Office Action Summary

10/565,469

MELZ ET AL.

第 3 図

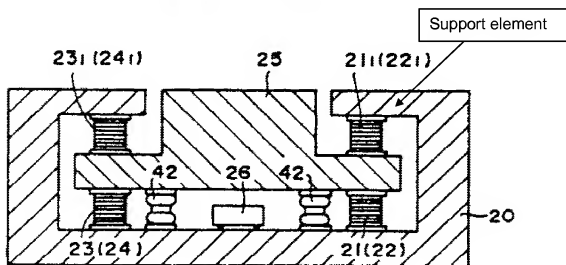
Re: claim 10, Katsumi shows an interface for reducing mechanical vibrations, as in the present invention, which has a base connection element 20, a load connection element 25 and at least one support element, as marked below, a) wherein at least a first energy converter system, 21, 23 bottom, extends between at least one engagement point located on the base connection element and at least one engagement point located on the load connection element; b) wherein at least one second energy converter system, 21, 23 top, extends between at least one engagement point located on the support element and at least one engagement point located on the load connection element; and d) wherein the load connection element 25 has a part located in an intermediate space between the base connection element and the support element, and a part located outside the intermediate space between the base connection element and the support element, as shown in figure 3. Katsumi lacks the

elastic pipe surrounding the actuators as claimed. Holland shows an tension damping device (elastic pipe 14 see column 4 lines 21-27) for a vibration damper in figure 1 in order to provide better damping performance (see abstract). It would have been obvious to one of ordinary skill in the art at the time the invention was made to have modified Katsumi's assembly to comprise an elastic pipe as taught by Holland et al in order to provide further dampening capability to the assembly of Katsumi at the same time protecting the assembly from environmental elements.
